Further Information

**Proposed Temporary Holiday Camp, Place of Recreation, Sports or Culture
(Barbecue Site and Hobby Farm) and Eating Place with Ancillary Facilities for a Period of 3 Years
and Associated Filling of Land in "Agriculture" and "Open Space" Zones and Area shown as 'Road',
Various Lots in D.D. 17 and Adjoining Government Land, Ting Kok, Tai Po, New Territories**

(S.16 Planning Application No. A/NE-TK/832)

Response-to-Comment (RtC)

FIGURE NUMBER
FIGURE 6

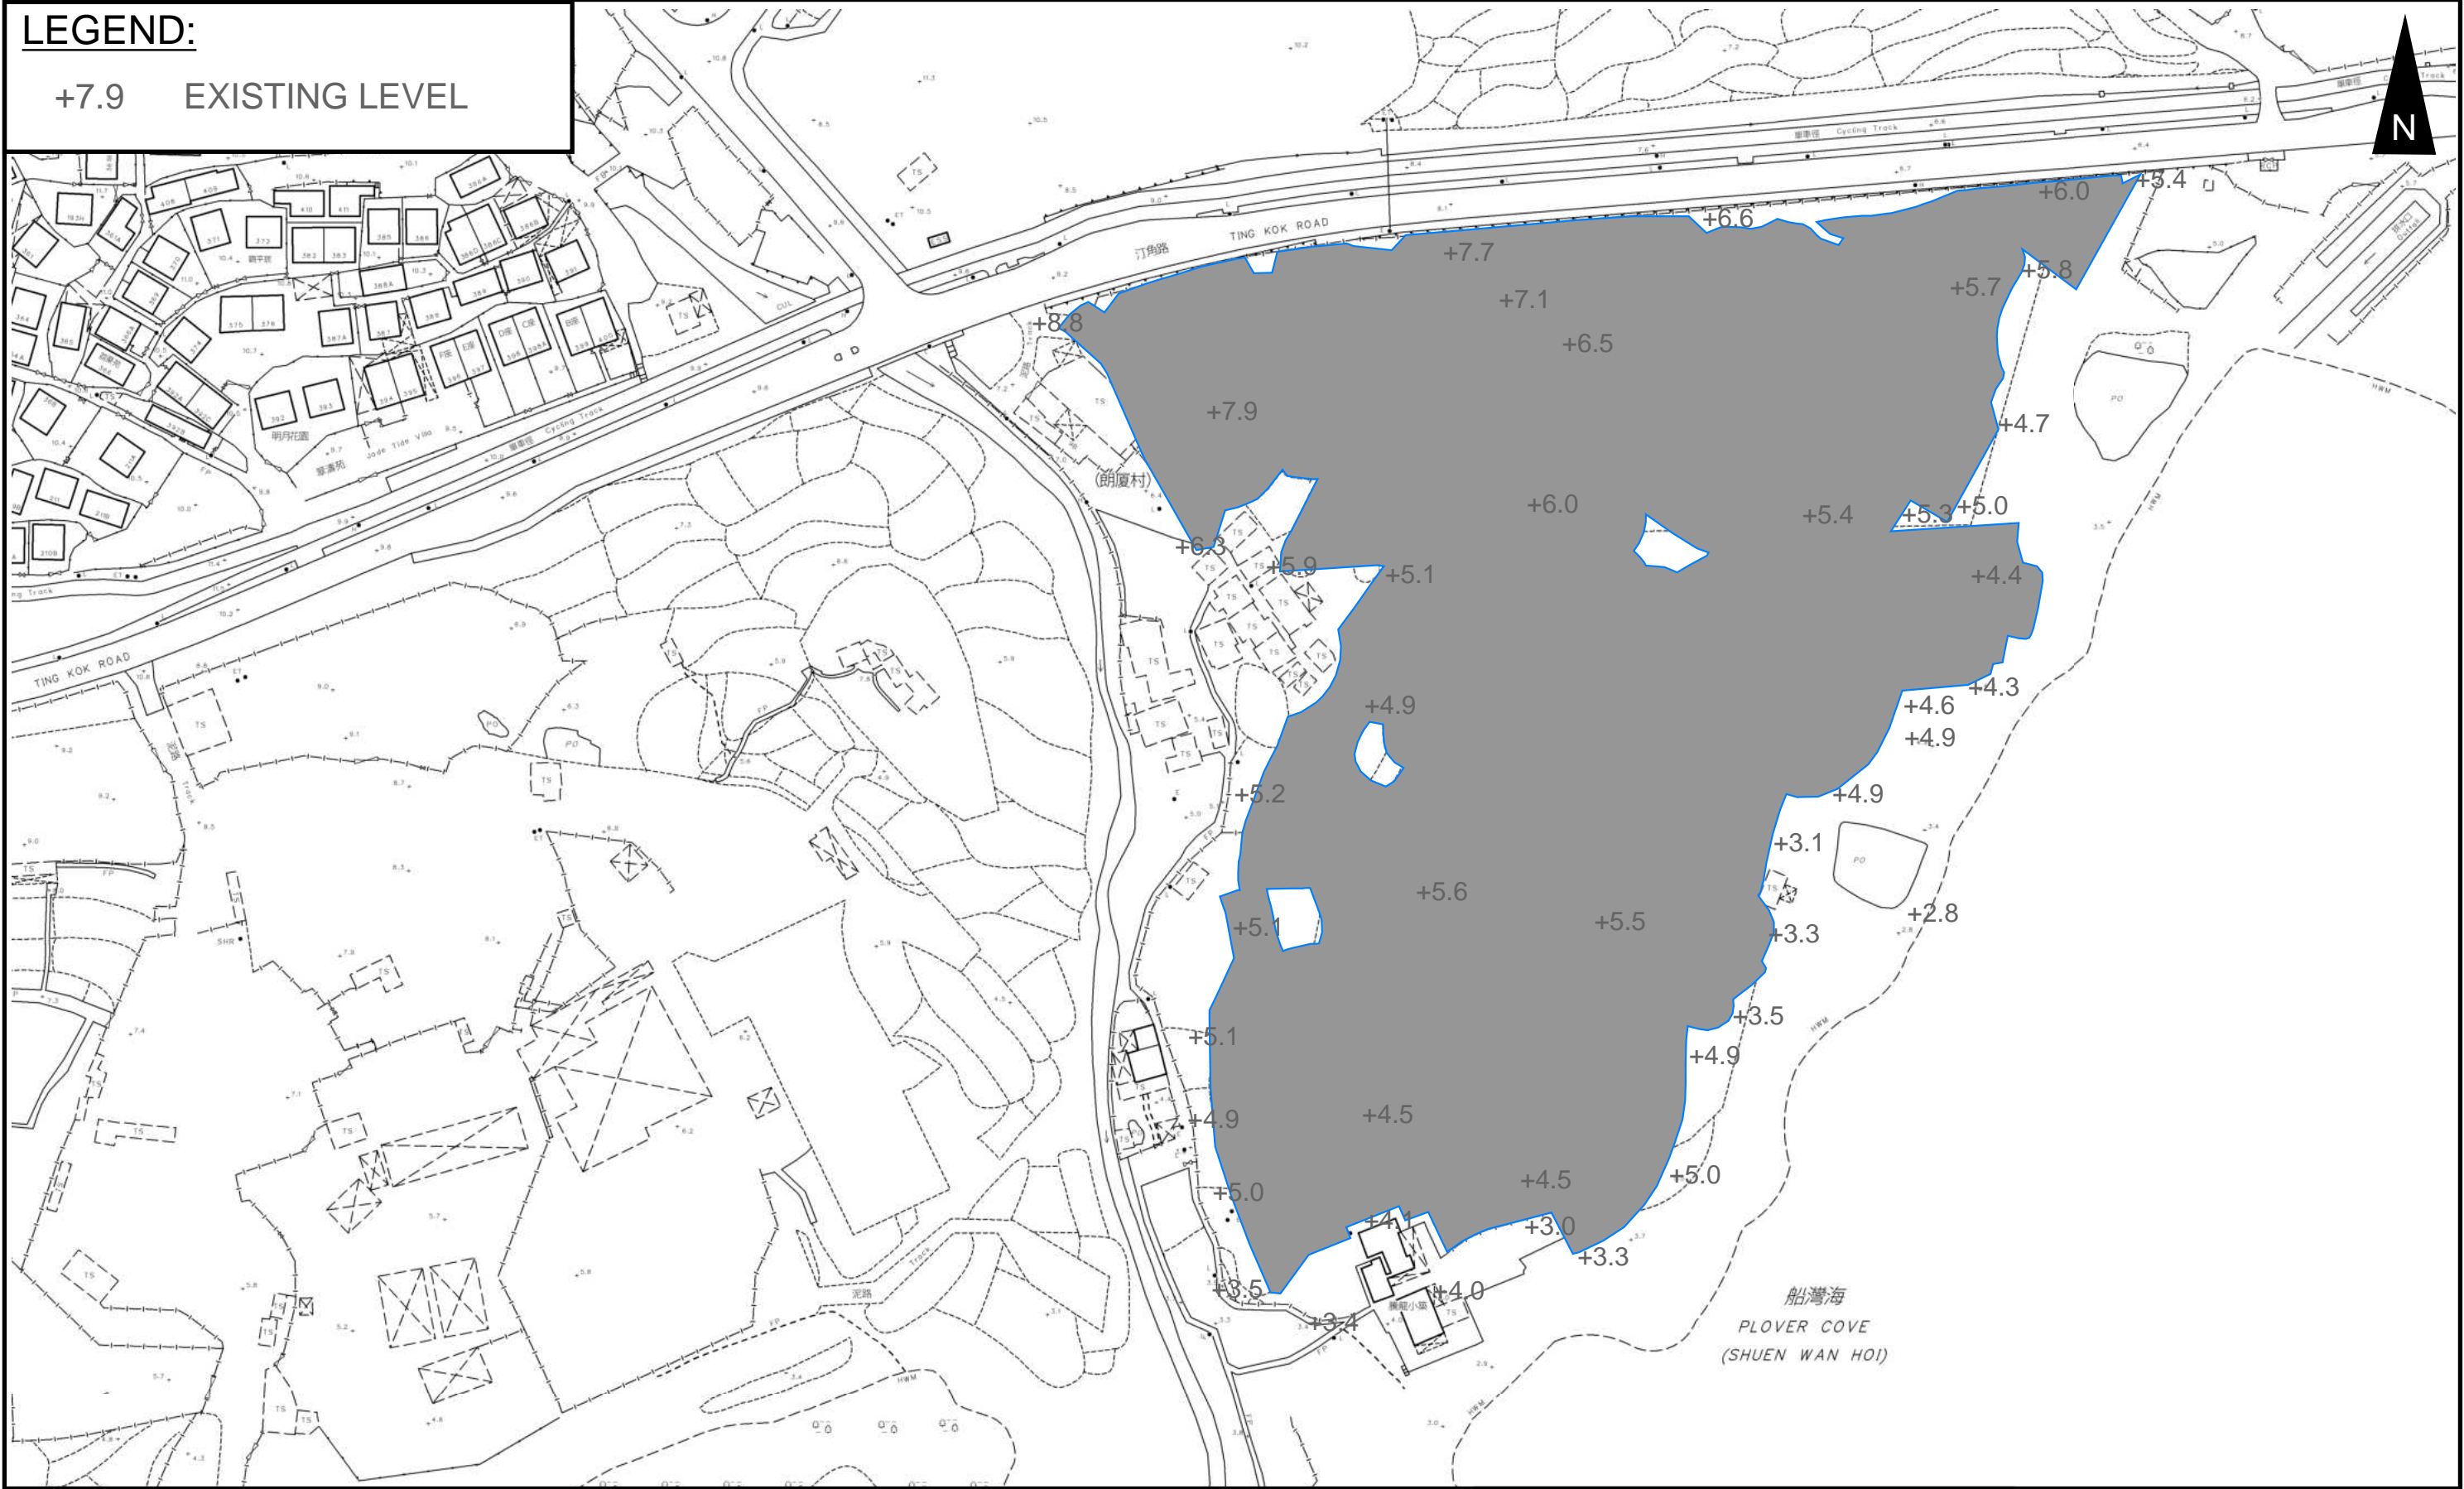
(d)	Please provide topography of the application site and adjacent areas before and after the proposed development.	Noted. Further to the discussion with DSD, Figure 6 shows more existing levels around the Site for your perusal.

Annex 2a
Revised Tree Survey Plan

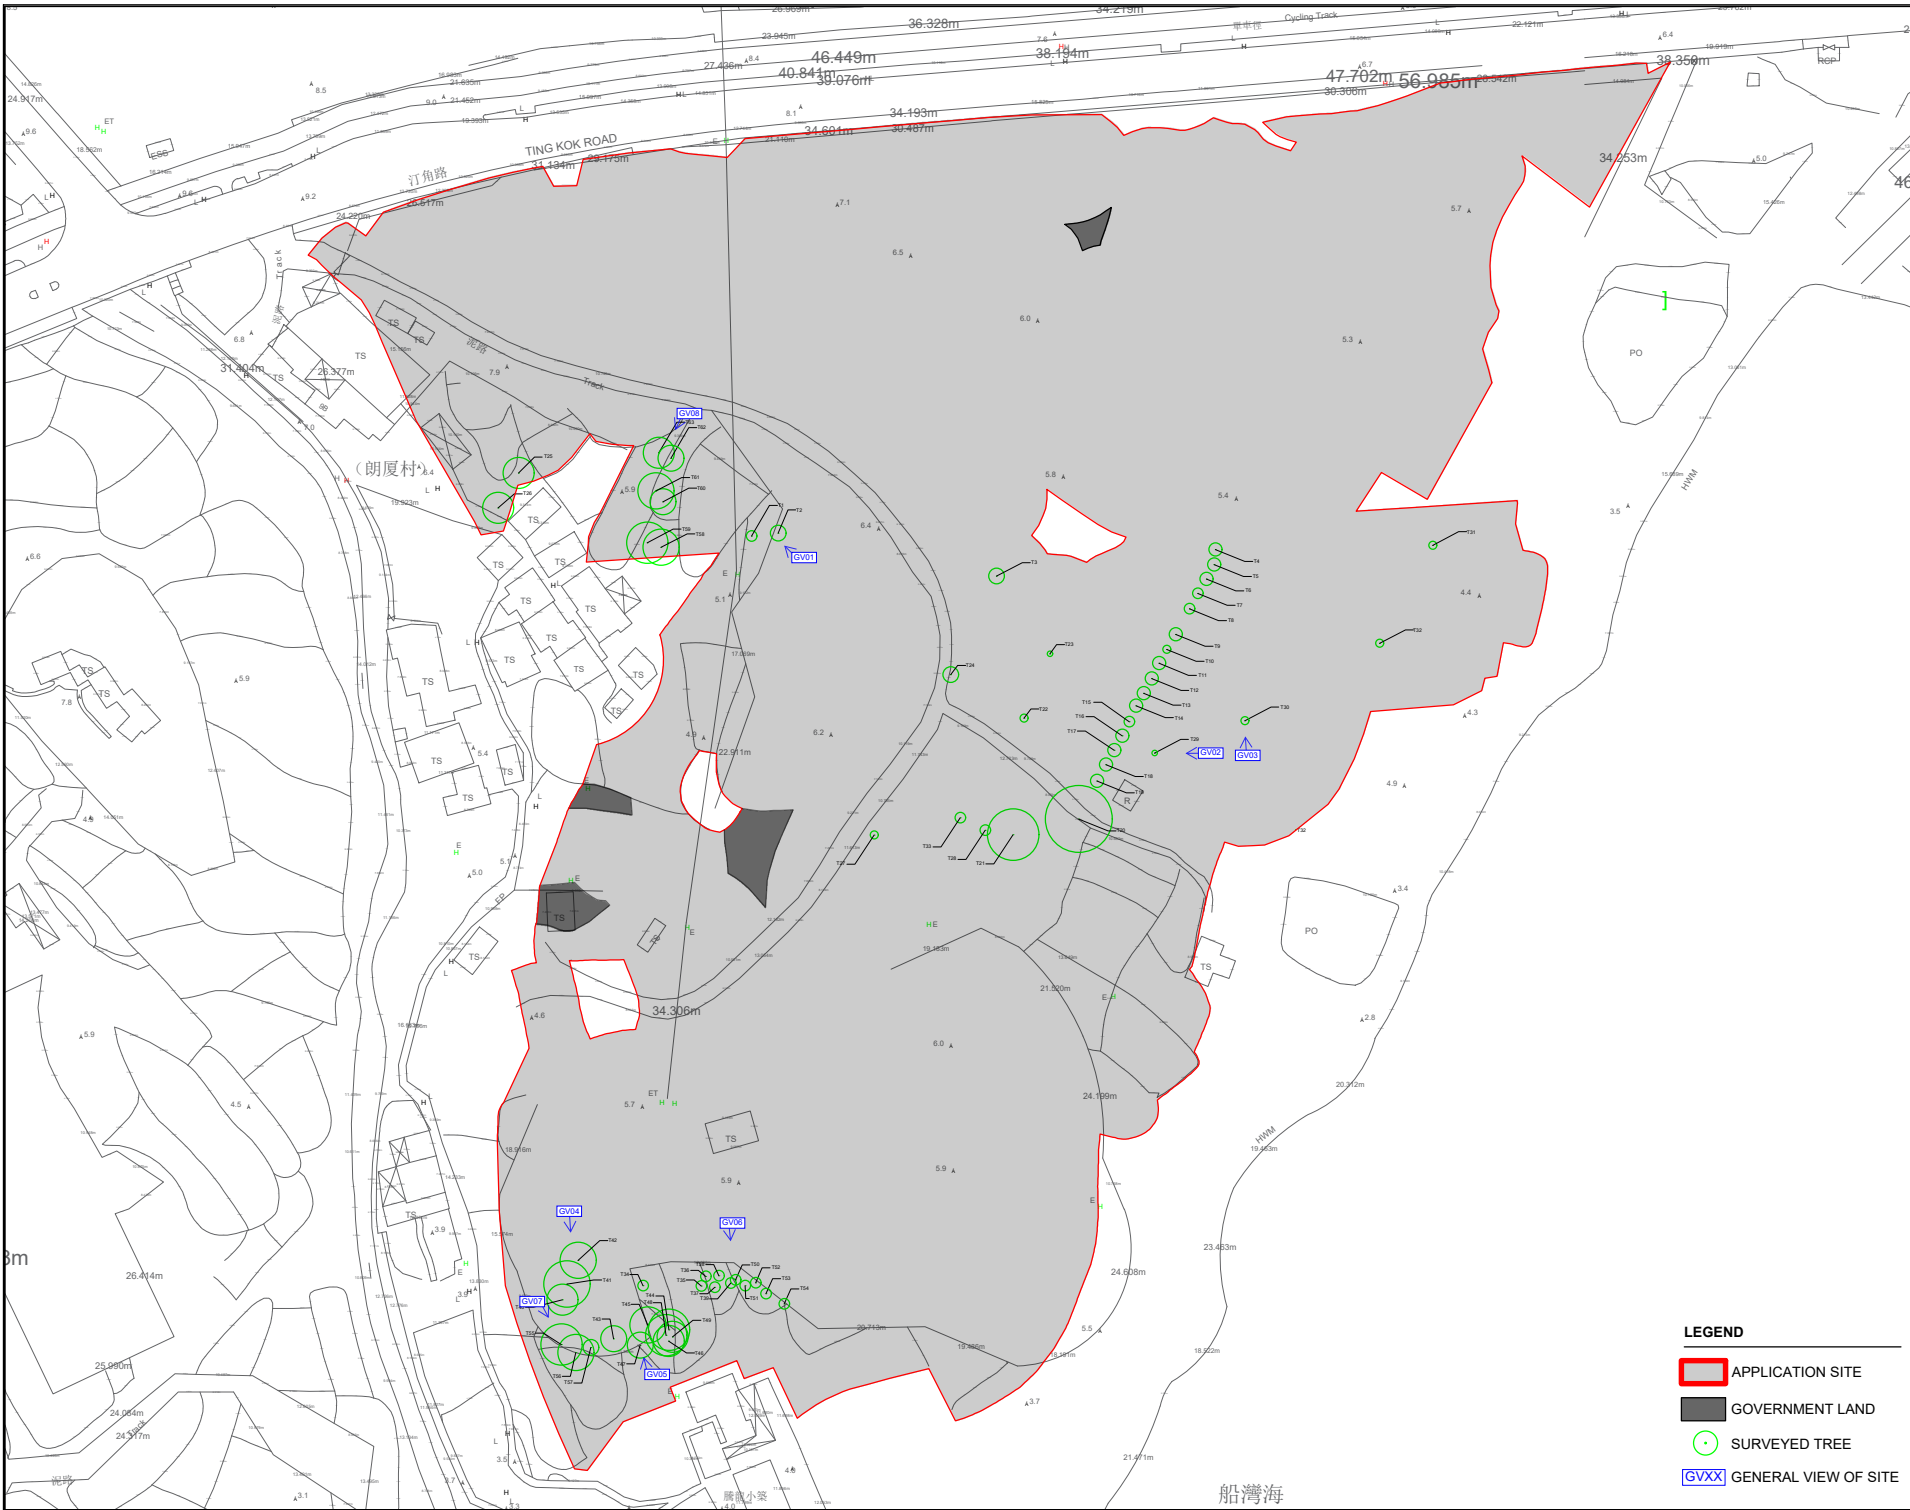
Departmental Comments		Applicant's Responses
2. Comments of the Chief Town Planner/Urban Design and Landscape, Planning Department (CTP/UD&L, PlanD)		
(a)	The applicant should explore every possible opportunity in preserving trees as far as practicable. If preservation or transplantation of mature/large trees (T20 and T41) are not feasible, full justifications with supporting information such as close-up photos showing defects (if any) should be provided.	Noted. In order to maintain the landscape quality as far as practicable, large trees labelled as T20 and T41 on the Tree Survey Plan will be preserved in-situ. Please refer to the revised Tree Survey Plan at Annex 2a .

(b)	Actual crown spread of existing and proposed trees should be indicated in scale on the tree survey plan and landscape plan.	Noted. The actual crown spread of existing and proposed trees has been indicated in scale on the revised Tree Survey Plan and Landscape Plan at Annexes 2a and 2b respectively.
